# Access Compliance Report

## Public Rights-of-Way

### (Curb Ramps)

Intersection ID: 47569	Main Street: ROWE_CT	Cross Street: HERMSLEY_RD	Location: W
ADA ID: 5BD54FB8E11F	Ramp Type: PerpDiag	Initial Pass/Fail: Fail	Overall Compliance: No
Severity Score: 35			
Codes/Mitigation Info/Possible Solution		Field Measurements/Component Compliance

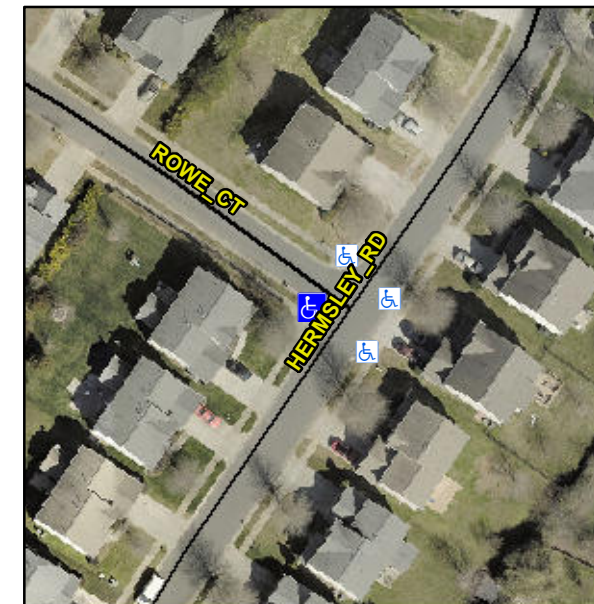
**R304.5.1, R304.2.2, R304.5.3**

Compliance	Description	Data	Compliance	Description	Data
N/A	Ramp Length (in)	48.0	No	Ramp Slope (%)	15.1
No	Ramp Width (in)	47.5	No	Ramp XSlope (%)	4.7
N/A	Flare Type LT	N/A	N/A	Flare Type RT	N/A
N/A	Flare Slope LT (%)	N/A	N/A	Flare Slope RT (%)	N/A
N/A	Flare Traversable LT?	N/A	N/A	Flare Traversable RT?	N/A
N/A	Landing Length (in)	N/A	N/A	DWS Provided?	N/A
N/A	Landing Width (in)	N/A	N/A	DWS Contrast?	N/A
N/A	Landing Slope (%)	N/A	N/A	DWS Length (in)	N/A
N/A	Landing X Slope (%)	N/A	N/A	DWS Full Width?	N/A
N/A	Landing Curb? (Y/N)	N/A	N/A	DWS Offset (in)	N/A
N/A	Shared Landing?	N/A			
N/A	Gutter Ponding?	N/A	N/A	Gutter Slope (%)	N/A
N/A	Gutter Lip Ht (in)	N/A	N/A	Gutter X Slope (%)	N/A
N/A	Painted X Walk1?	No	N/A	Painted X Walk2?	No
	X Walk 1 Direction	To SE		X Walk 2 Direction	To NE
N/A	X Walk 1 Width (in)	N/A	N/A	X Walk 2 Width (in)	N/A
	X Walk 1 Slope (%)	2.1		X Walk 2 Slope (%)	3.0
	X Walk 1 X Slope (%)	2.6		X Walk 2 X Slope (%)	1.3

N/A	Ramp inside XWalk1?	N/A	N/A	Ramp inside XWalk2?	N/A
	Road Slope (%)	2.9	N/A	Clear Space?	N/A
	Road X Slope (%)	1.4	N/A	Clear Space to XWalk (in)	N/A
N/A	Any Obstructions?	N/A	N/A	Storm Grate/Utility Hazard?	N/A
	Obstruction Type			Storm Grate/Utility Type	
		N/A			N/A
			Yes	Surface Condition? (G/P)	Good

**Remove & Replace Curb Ramp With Two New Directional Ramps or Equivalent.**
